REZONING PLAT FOR:

PETITION NO: Z-70
HEARING DATE (PC): 11-07-17
HEARING DATE (BOC): 11-21-17
PRESENT ZONING: RM-8
PROPOSED ZONING: RD

ZONING COMMENTS:

Z-70 JOE A. MCHARG

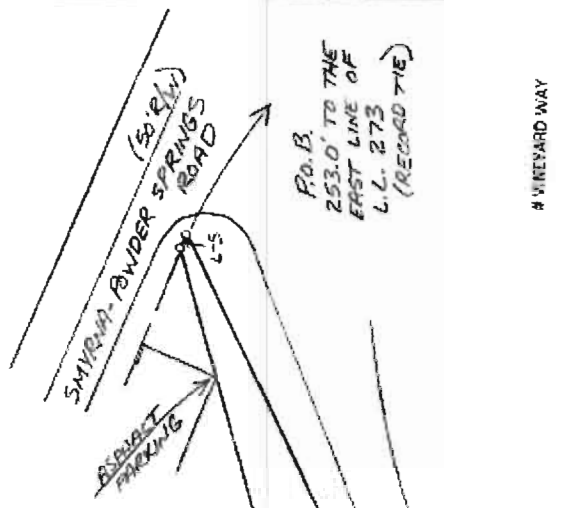
1. Waive the rear setback from the required 40 feet to 35 feet with an increase in both the major side yard and minor side yard setbacks to 35 feet (from 25 feet and 20 feet, respectively).

- No Stormwater controls shown – Stormwater management must be provided for this site.
- Copy of survey is not current – Additional comments may be forthcoming when current site conditions are exposed.
- No site improvements showing on exhibit.

Recommend applicant consider entering into a development agreement pursuant to O.C.G.A. 36-71-13 for dedication of the following system improvements to mitigate traffic concerns: a) donation of right-of-way on the south side of Smyrna Powder Springs Road, a minimum of 40' from the roadway centerline.

Recommend entrance directly align with Chateau Lane.

Recommend curb, gutter, and sidewalk along the Vineyard Way frontage.

1. Site plan received by the Zoning Division on September 5, 2017, with the District Commissioner approving minor modifications;
2. District Commissioner to approve building architecture;
3. Fire Department's comments and recommendations;
4. Sewer and Water Division's comments and recommendations;
5. Stormwater Management Division's comments and recommendations;
